**A12 Chelmsford to
A120 widening scheme**

TR010060

**DEVELOPMENT CONSENT ORDER
CHANGE APPLICATION:
TRANSPORT ASSESSMENT ADDENDUM**

**Development Consent Order Change Application:
Transport Assessment Addendum**

Plate C-1 Traffic flow changes in 2027

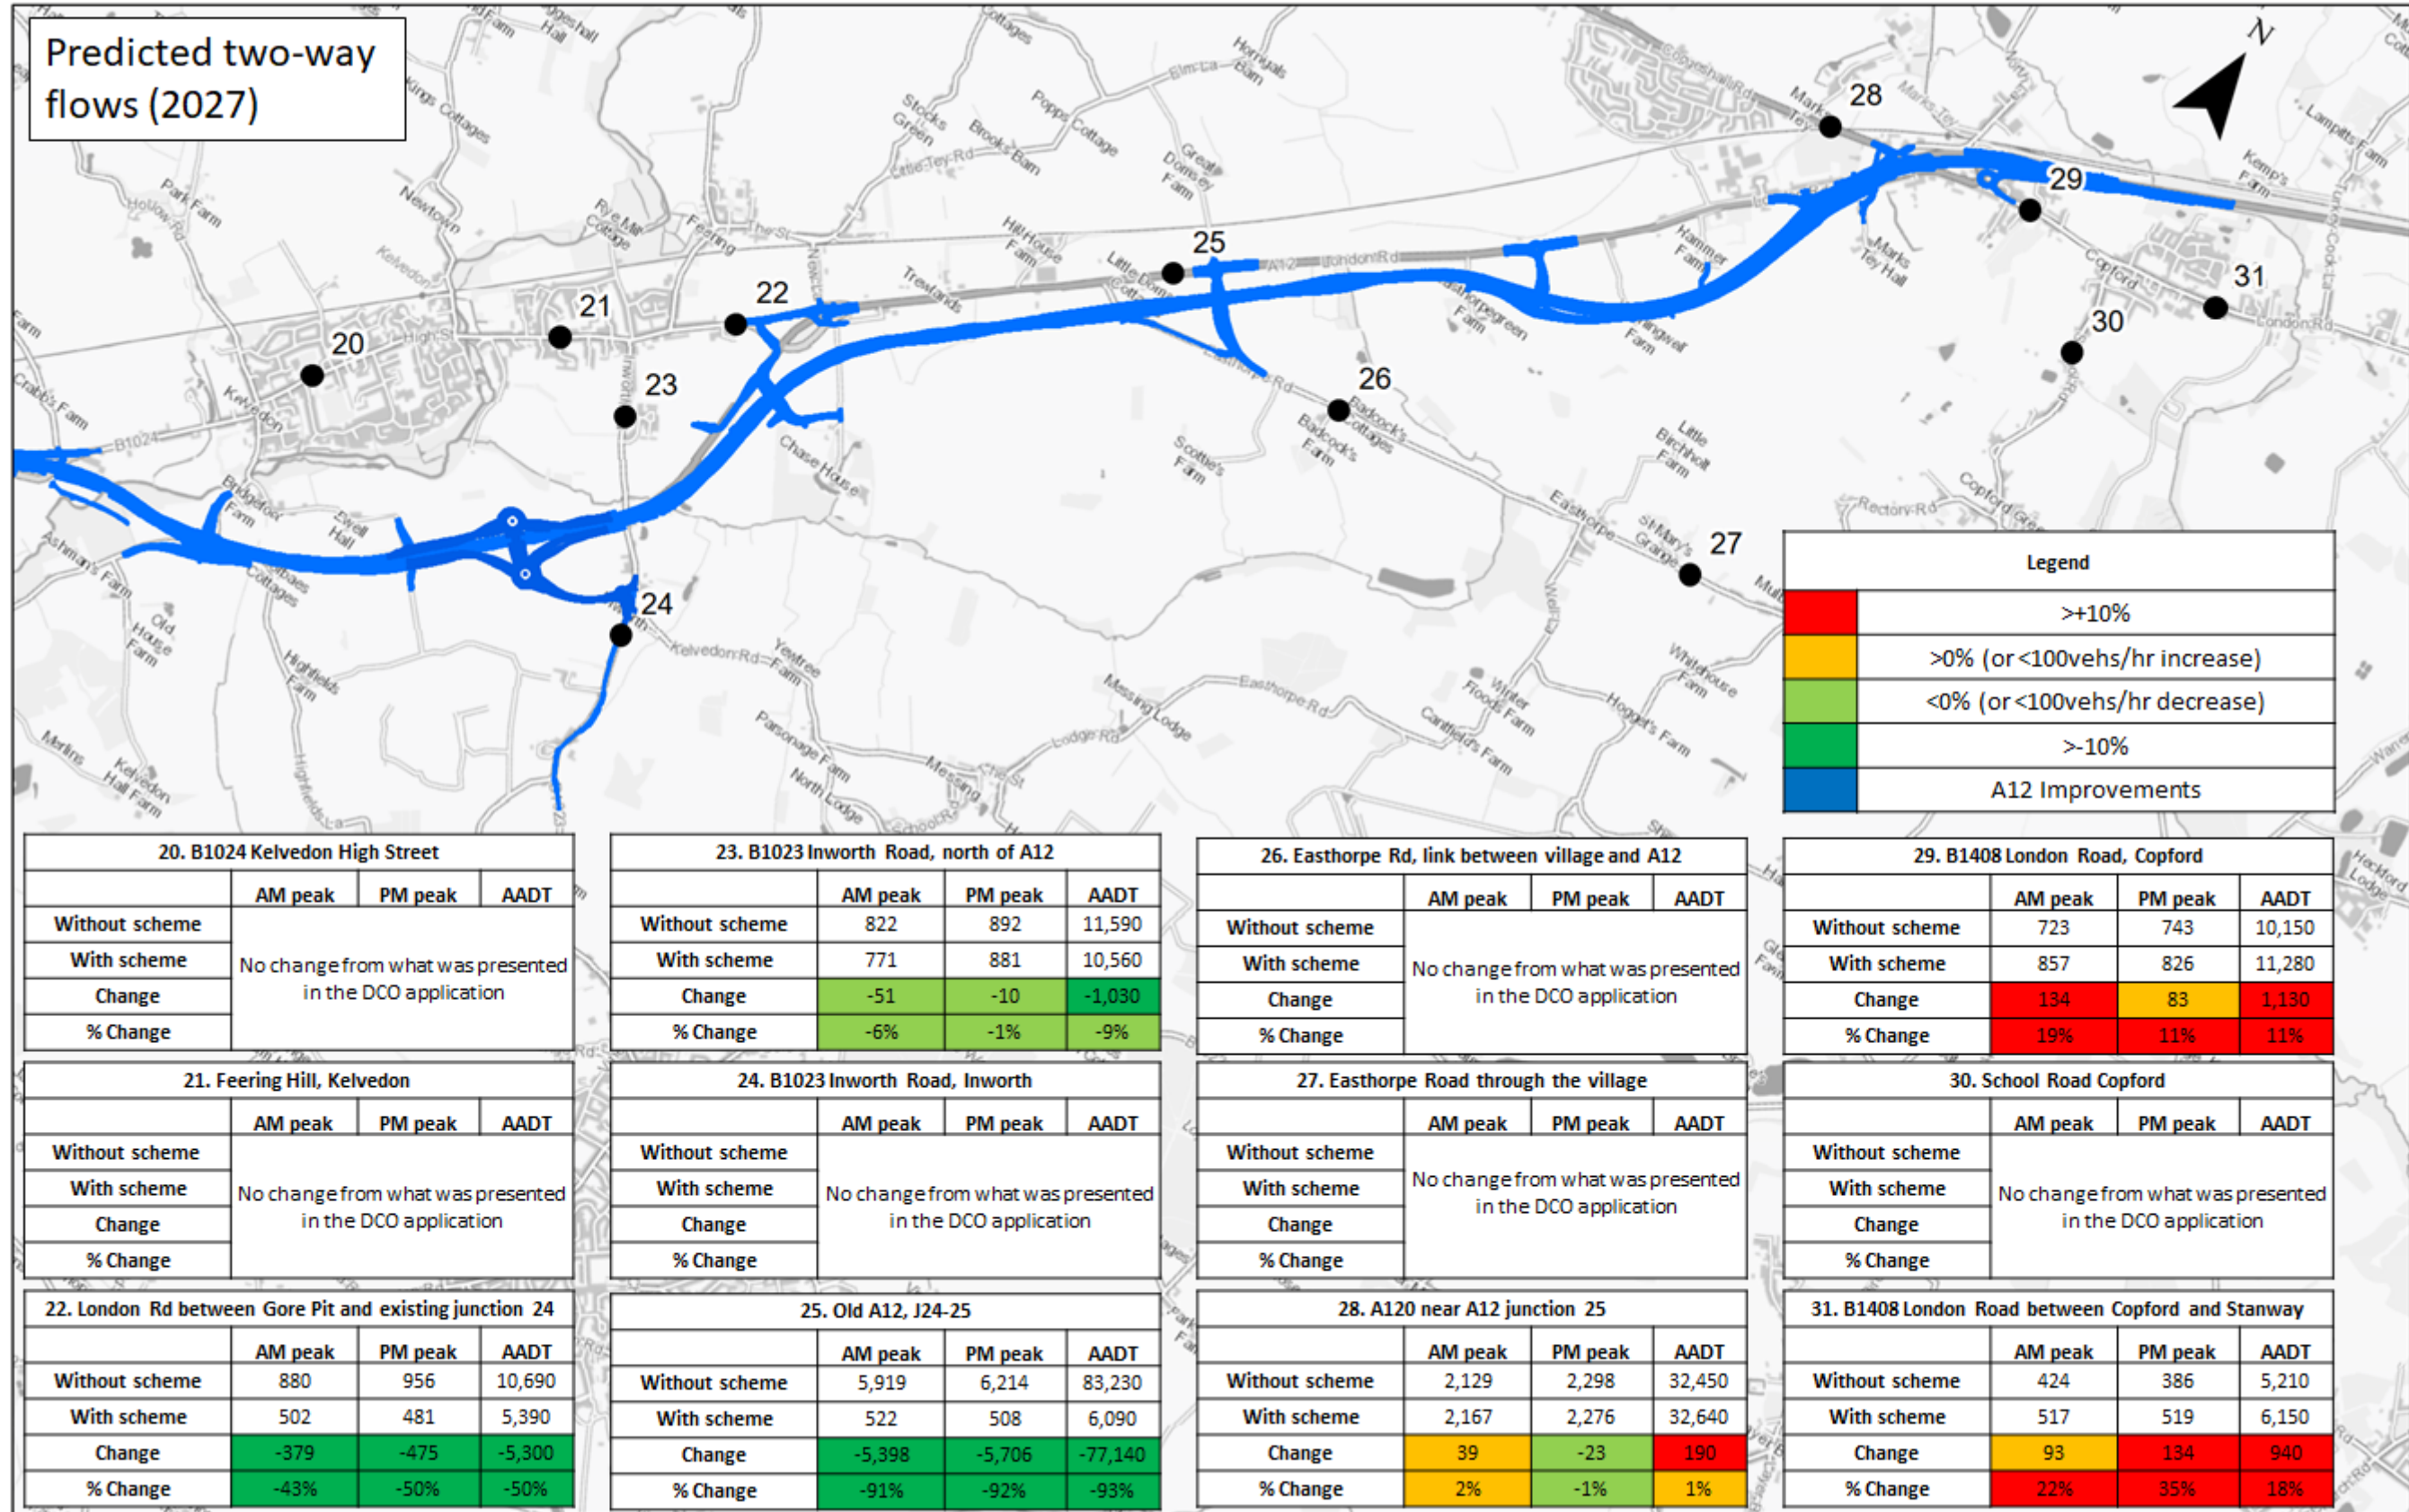
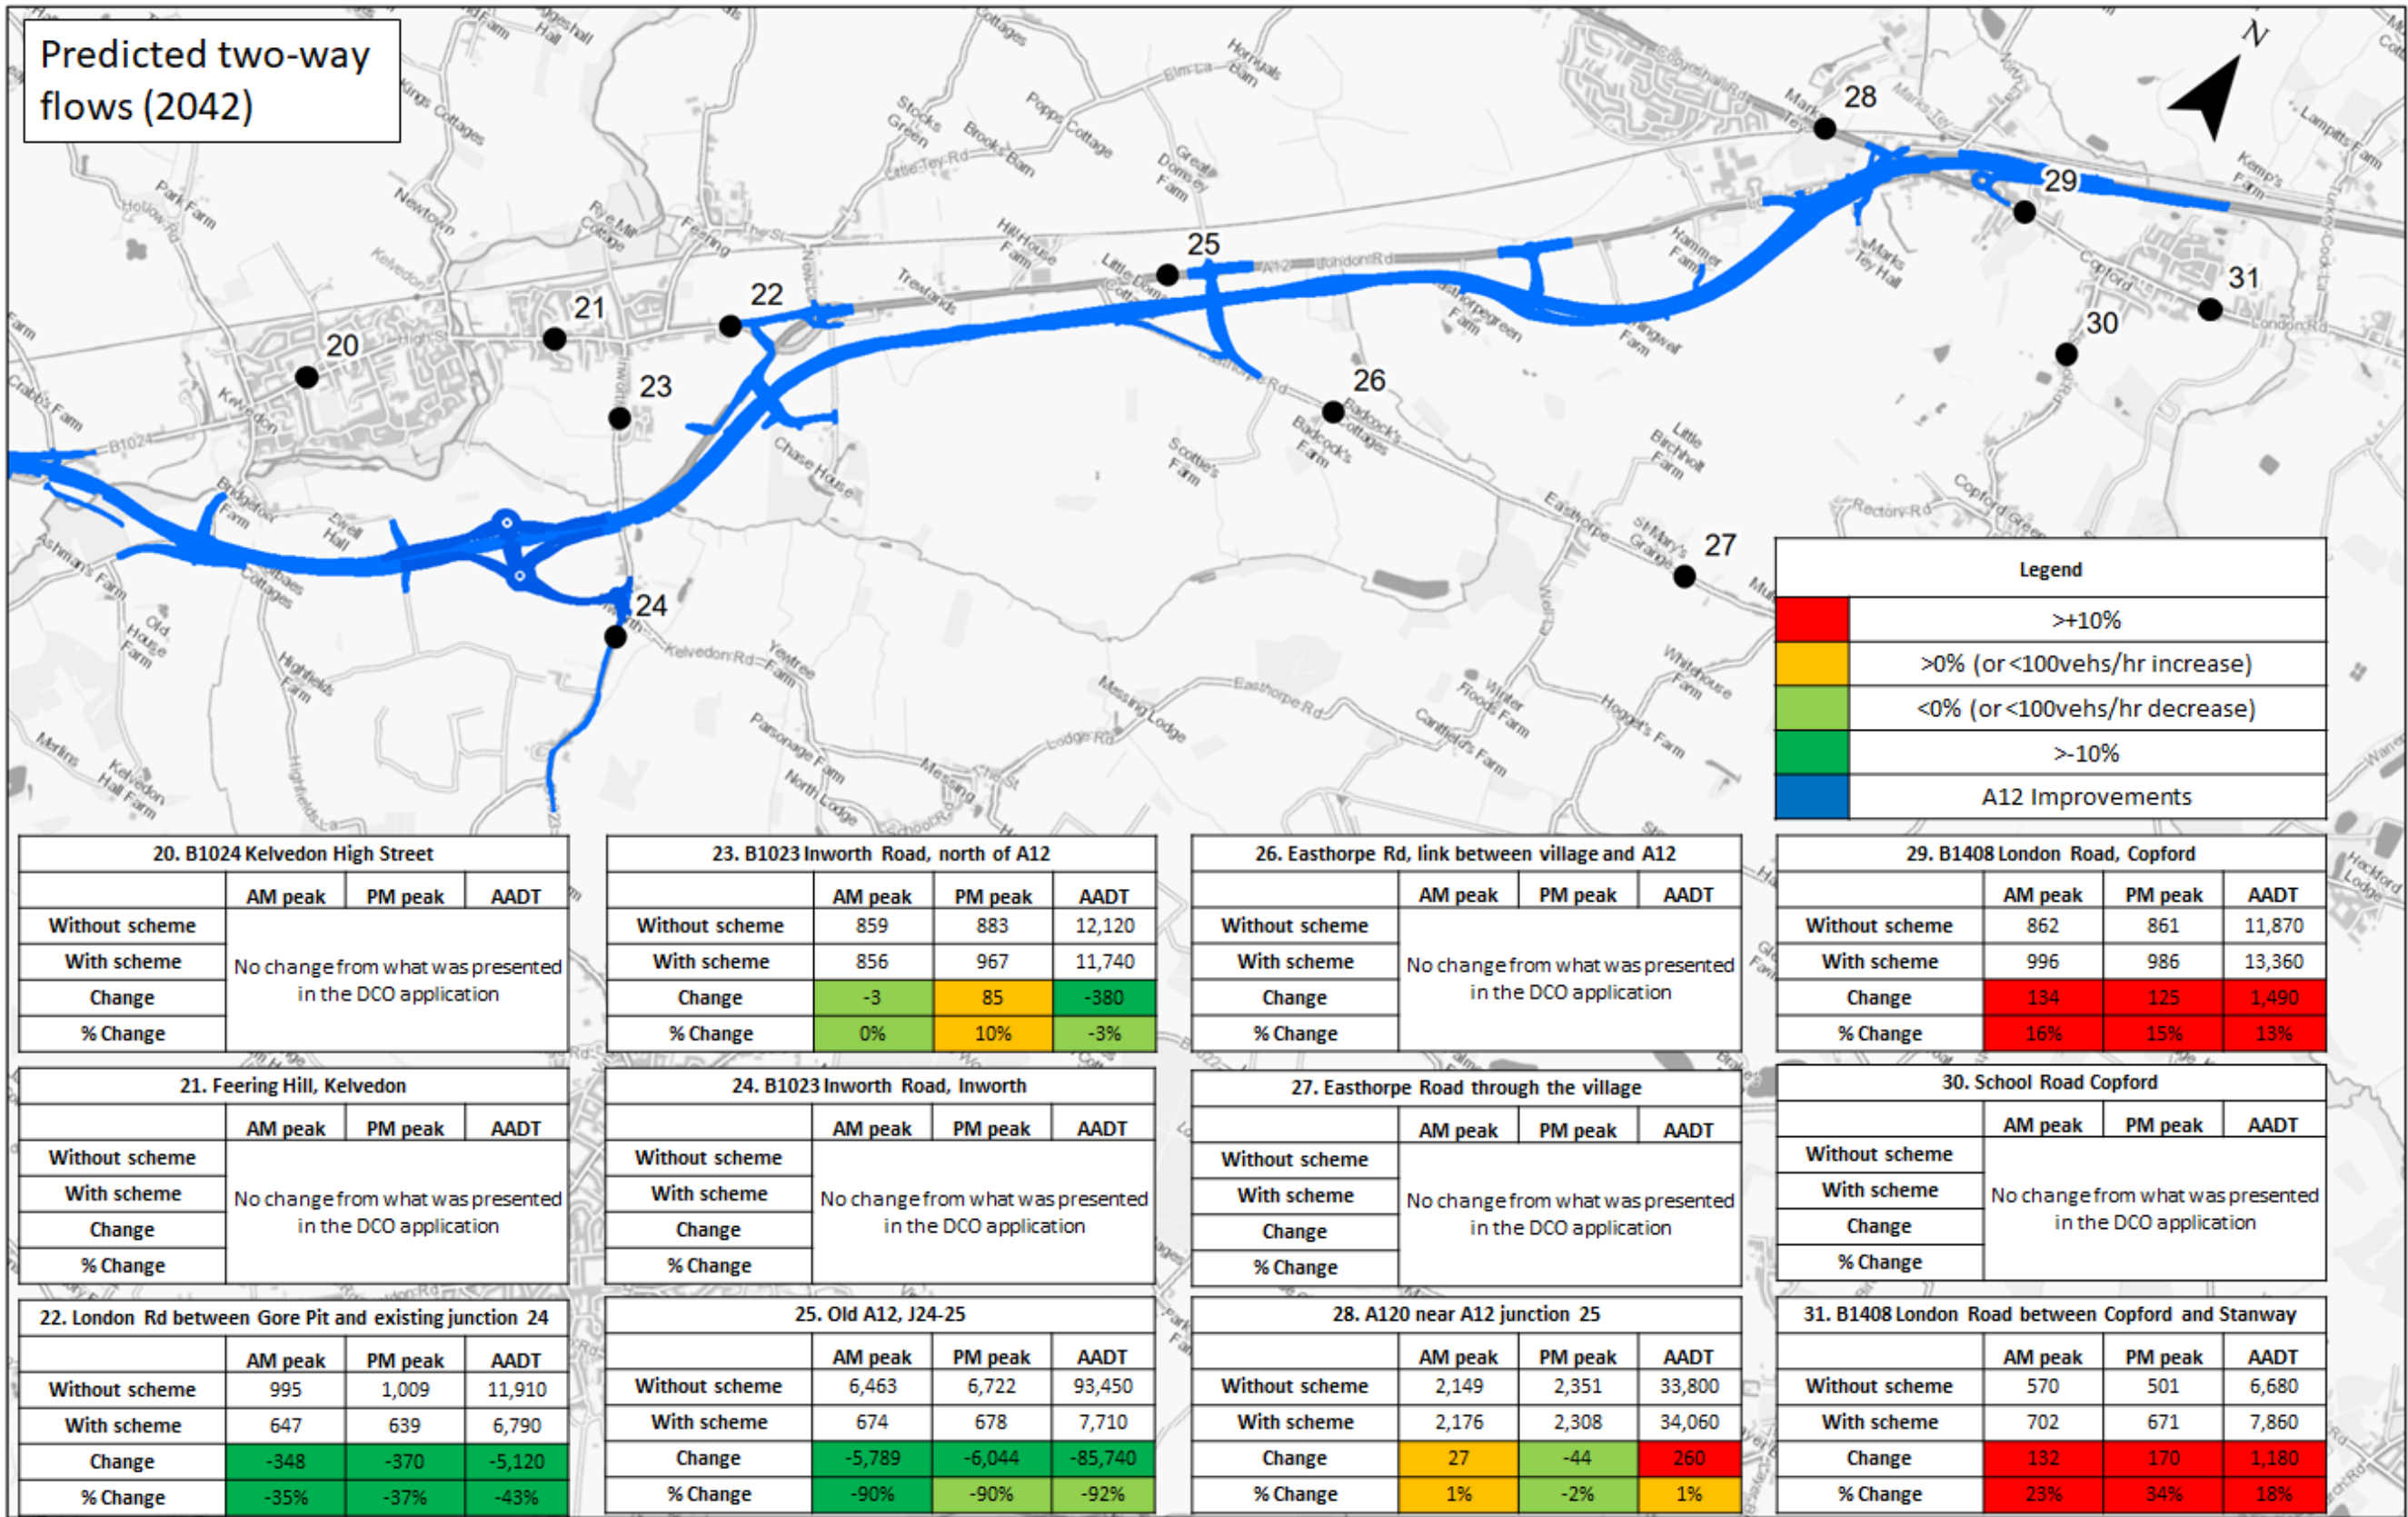
As described in Chapter 2, only the proposed changes at A12 junction 25 are predicted to affect flows on the local road network. The traffic flow changes shown in the following images are therefore focussed around Junction 25.

The traffic flows presented in this Appendix supersede those shown in images C.3 and C.9 in Appendix C of the original Transport Assessment [APP-256]. All other images shown in the original Appendix C remain unaffected.

Plate F-2 Junction 25 with Scheme Vissim Model Extents

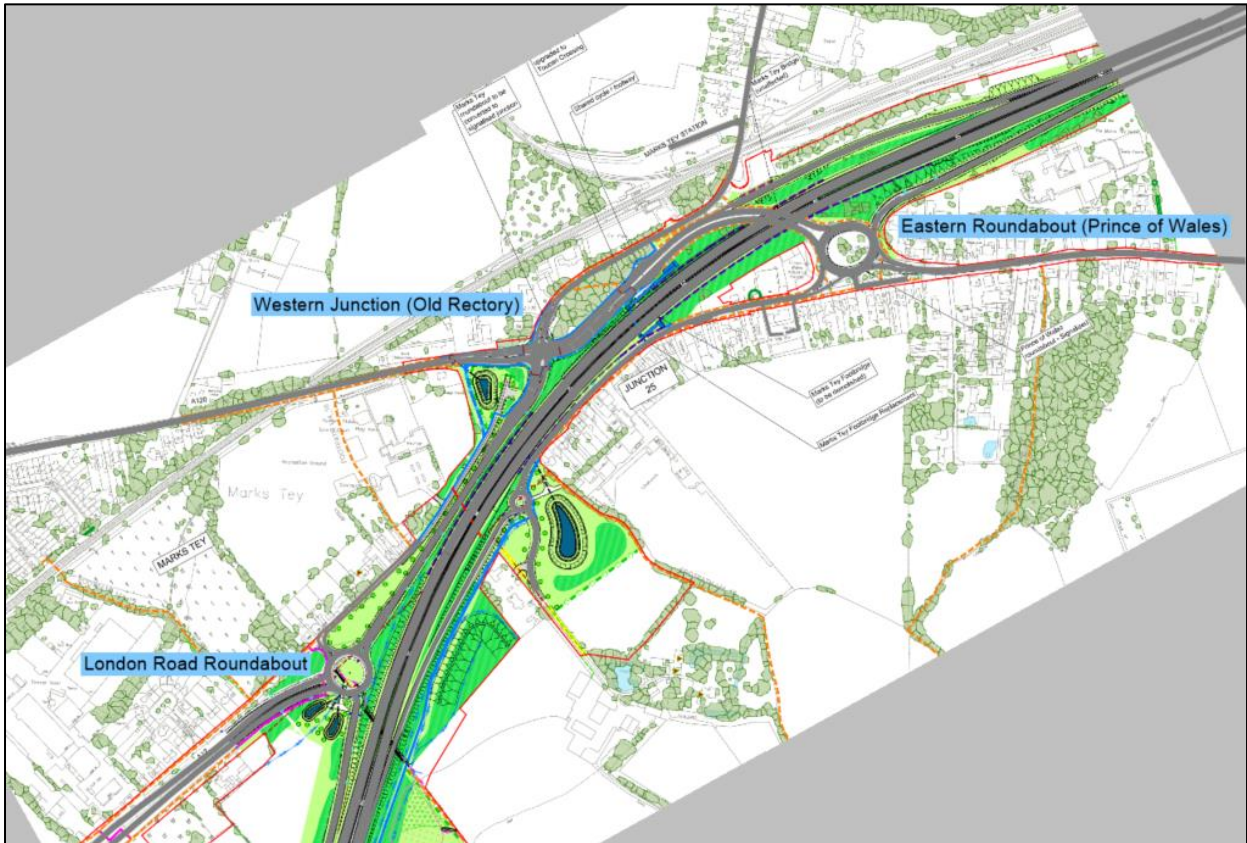
For the 'Future Operation with Scheme' scenario, the Vissim model has been updated to reflect the partially-signalised roundabout design.

The Vissim model extents are shown in Plate F-2. Details of the junctions included in the model are described in Table F-5.

Plate F-3 Junction 25 Partially Signalised Roundabout

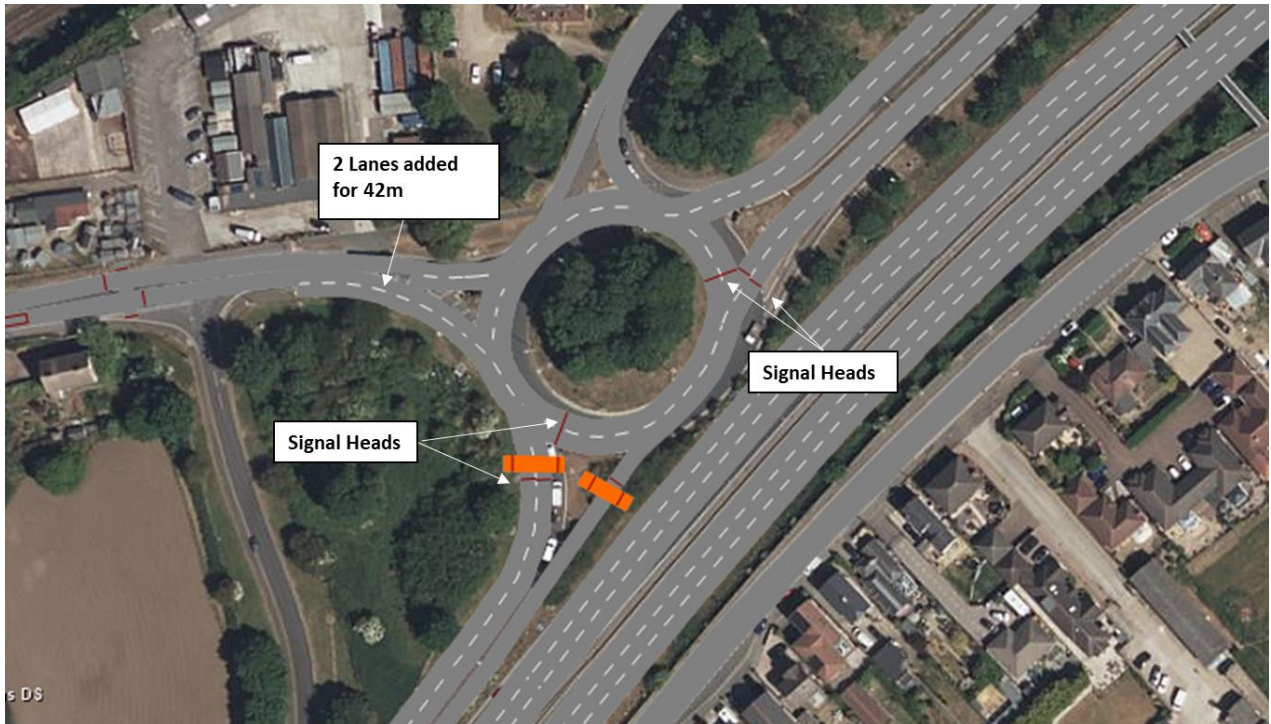
Greater detail of the junction 25 Western Roundabout (Old Rectory Junction) model layout is shown in Plate F-3.

In the 2027 PM peak and the 2042 AM peak, the Old Rectory Junction (Western Junction) would improve from a Level of Service D (categorised as ‘approaching unstable condition’) in the original DCO application to a Level of Service C (categorised as ‘stable flow condition’). Because traffic would be able to flow more freely through the Old Rectory Junction, the adjacent Eastern Roundabout would become slightly busier. This would result in a lowering of the Level of Service from a C to a B, although both Levels of Service C and B are still categorised as having ‘stable flow condition’.

In the 2042 PM peak, the Station Road arm of the Western Junction (Old Rectory Junction) would reduce from a Level of Service E in the original DCO application to a Level of Service F under the proposed changes. However, the increase in delay that causes this change in Level of Service is only 8 seconds.

Plate F-4 1 2042 AM Peak Future Operations with Scheme Average Queue Lengths

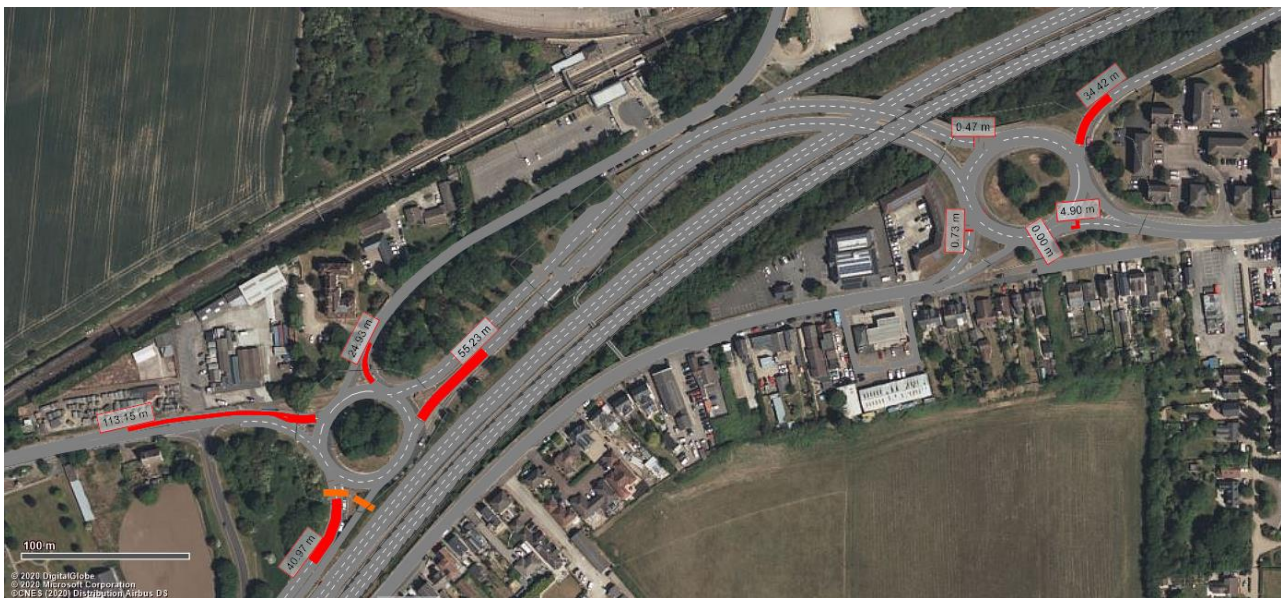
Plate F-4 and F-5 illustrate the average queue lengths on each approach to the Old Rectory Junction roundabout and Eastern roundabout at junction 25 for the AM and PM peaks respectively, for 2042. The average queue lengths are identifiable by the red blocks and the queue length distance is also reported (m). These images supersede Plates F10-15 and F10-16 in Appendix F of the original Transport Assessment.

In 2042 the queues at the Old Rectory Junction on the A120 Coggeshall Road approach are predicted to be 100m in the AM peak and 113m in the PM peak. This compares to 30m in the AM peak and 40m in the PM peak in the original DCO application. However, the actual delay per vehicle on this arm reduces by 10 to 15 seconds with the proposed changes compared to the original DCO application..
